Manuscript Status Update On (ID: 14830782): Current Status – Under Peer Review- Using Sustainble Architectural Wind-Driven Tubes Roof-Pond to Save Energy on Roof Cooling Loads in Tropical Climate: CFD Modeling and Experimental Investigations

Revision after Peer Review (ID:14830782)-2 reports-Using Sustainble Architectural Wind-Driven Tubes Roof-Pond to Save Energy on Roof Cooling Loads in Tropical Climate: CFD Modeling and Experimental Investigations

Manuscript ID:	**14830782**
Manuscript Title:	**Using Sustainable Architectural Wind-Driven Tubes Roof-Pond to Save Energy on Roof Cooling Loads in Tropical Climate: CFD Modeling and Experimental Investigations**

For instant: original (left) **Revised figure (right)**

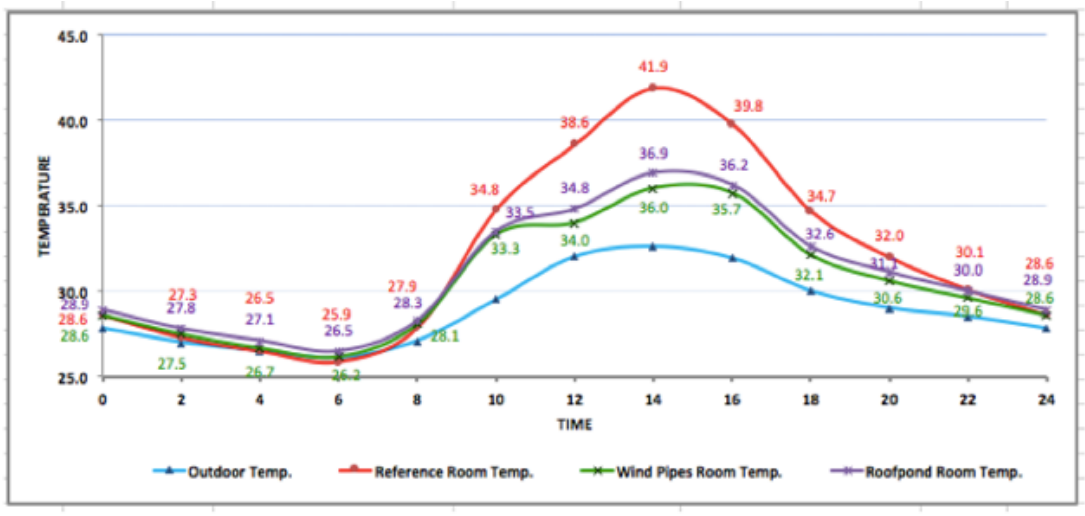
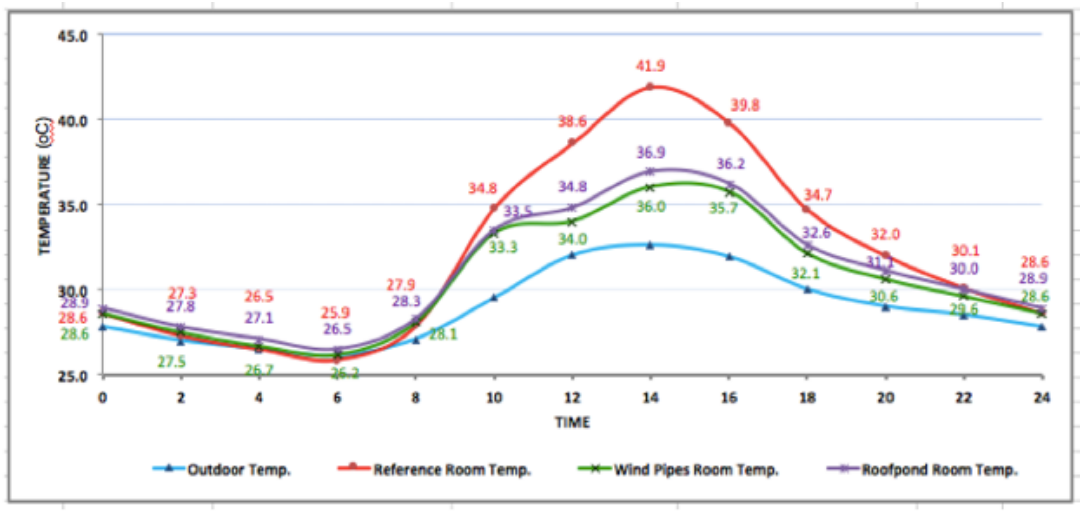
GeneralComments	**The studies presented in the article are complex. They are made at a high technical level. The analysis of the results is reasoned and contains exact indicators of values recommended for practical application.**
Advantage& Disadvantage	**The article contains a large number of drawings. Some of them can be excluded. At the same time, it is desirable to keep the description of processes and results in text form.**
How to improve	**Figure 12 can be excluded from the article. It illustrates the interface of the research software tool, the results of which are shown below.** **In figures 8 and 10, temperature units (°C) should be added to the y-axis for all graphs.**

Reviwer 3:
Adding Y axis Temperature with (oC) on Figure 8a, 8b, 10a, 10b, 10c, and 10d

Figure 1. Max. and Min. temperature, wind speed annually (Source: NASA, 2022) [3]

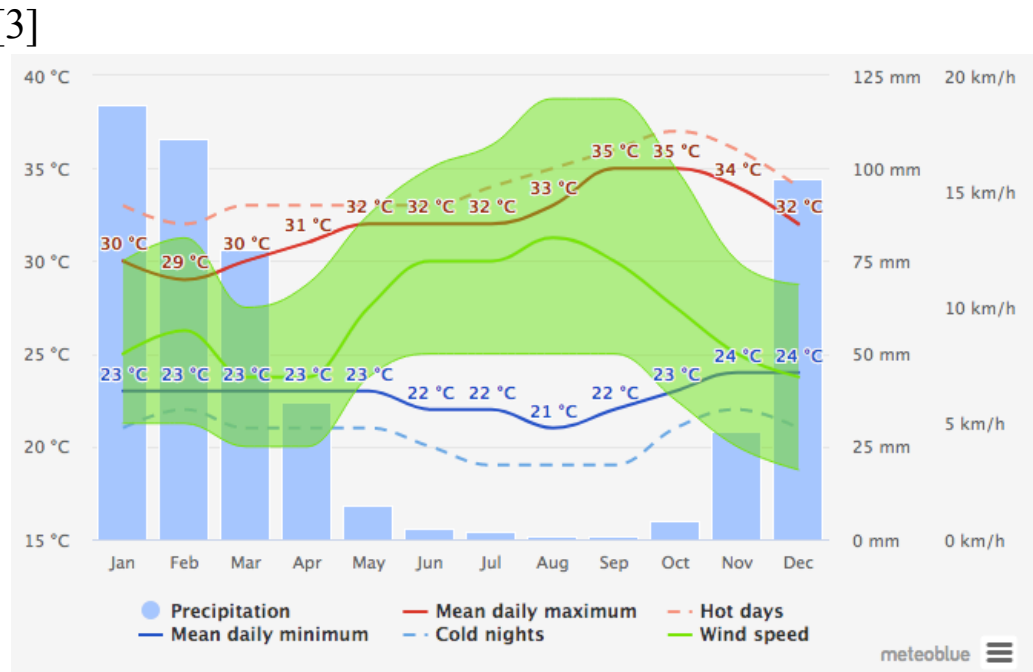
3. Figure 1, figure 2a, figure 2b, figure 3 and figures 5-12 are unclear. Please provide us the figures with high resolution to allow for reading the details of them. And make sure that all lines and lettering within the figures are legible at final size.

Figure 3. (a) Conventional concrete rooftop with V shading device, (b) Conventional roof-pond with V shading device, and (c) Wind-driven roof-pond with submerged iron tubes and V shape shading devices.

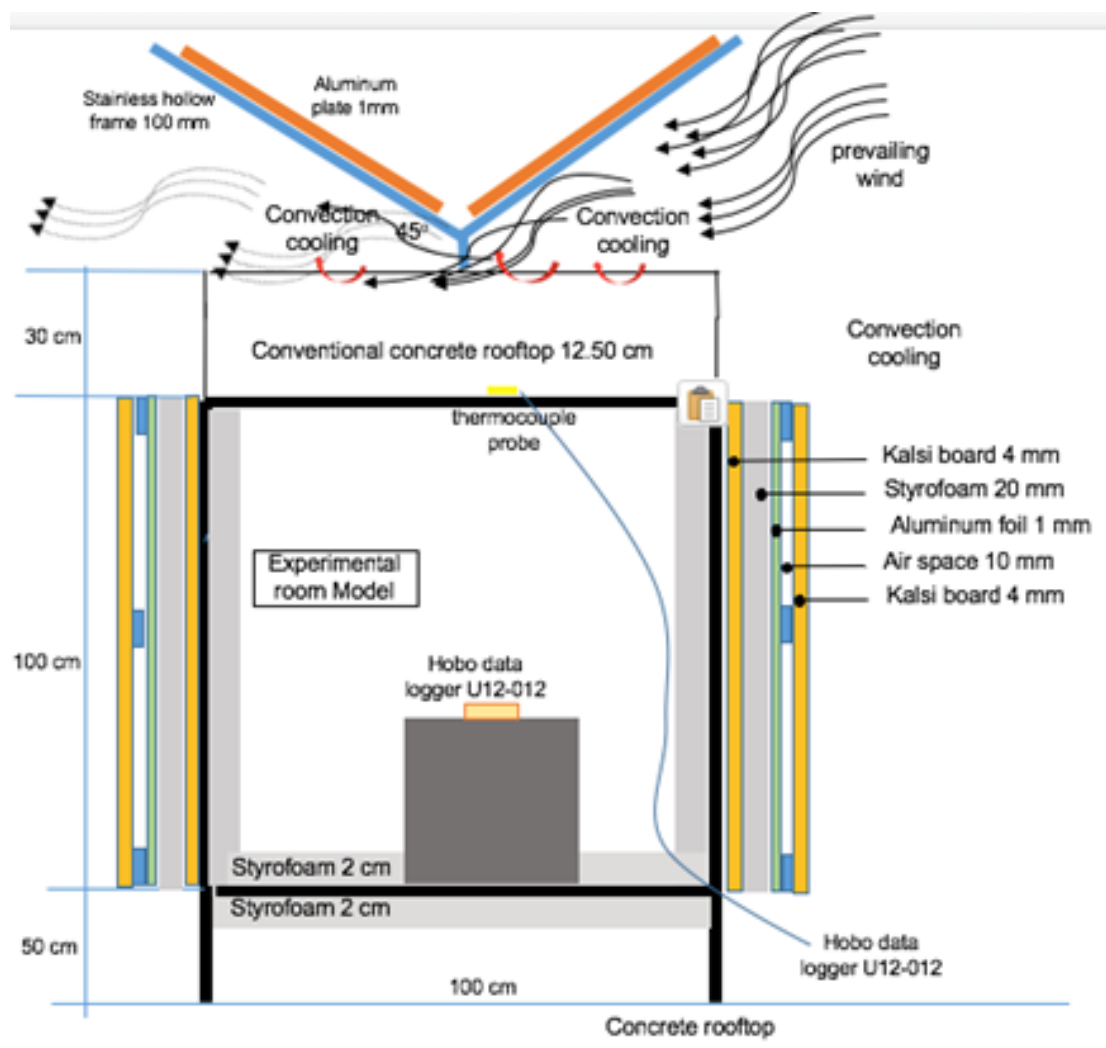
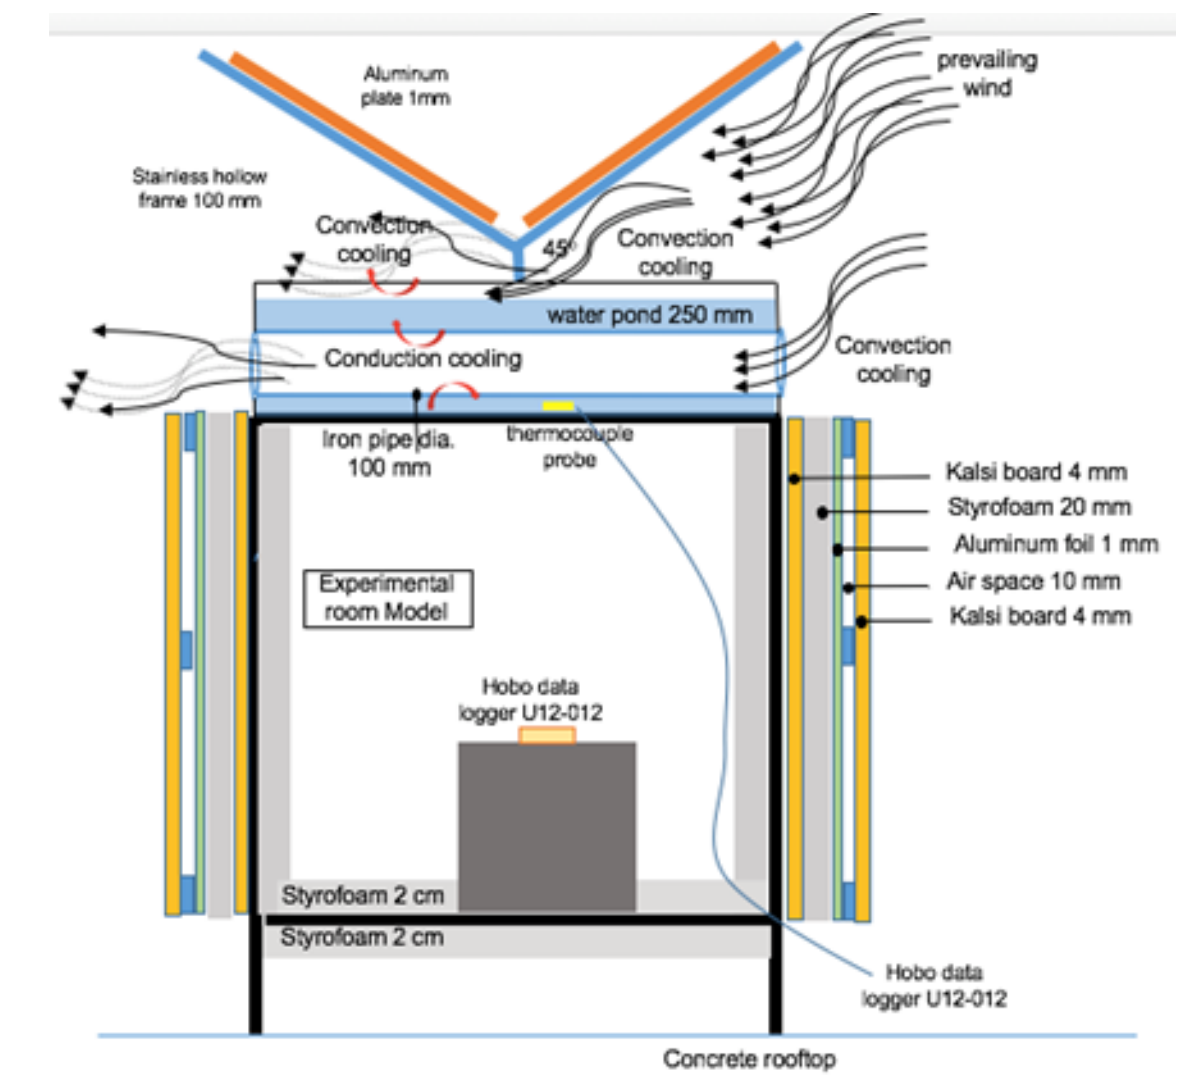
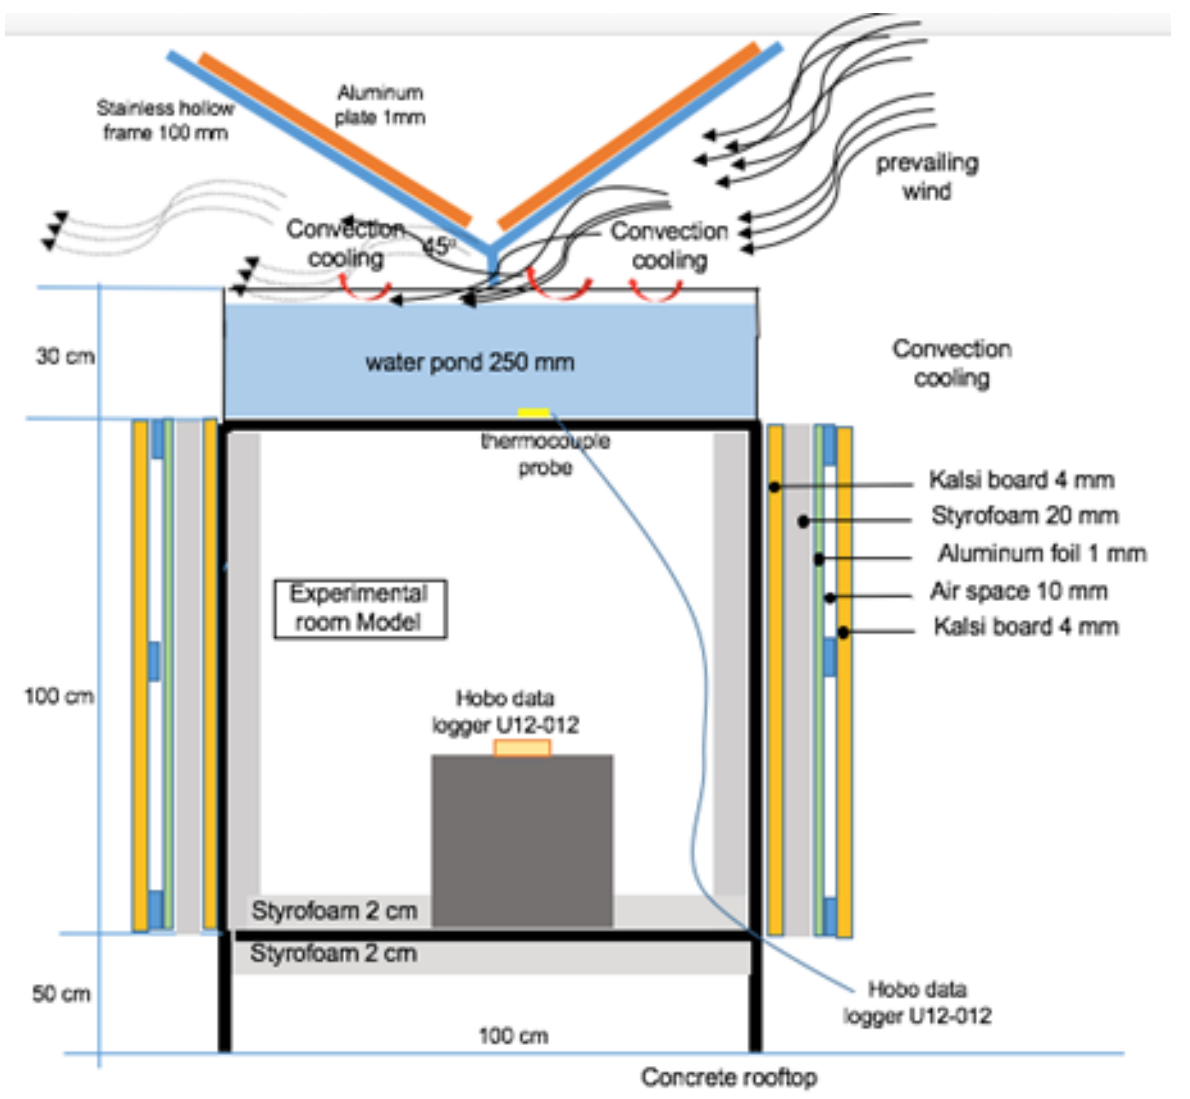
General Comments	**The work is interesting, the objective is fulfilled and the methodology allows a relationship between simulation and field work.**
Advantage & Disadvantage	**no comment**
How to improve	**Figures 3 (a, b and c) and table 3, improved resolution is recommended** **Is important that 80% of the bibliography to be 5 years old**

Figure 3a, b, c and Table 3
I attach with master files (creating with powerpoint), Table 3 has been replaced with excel file.
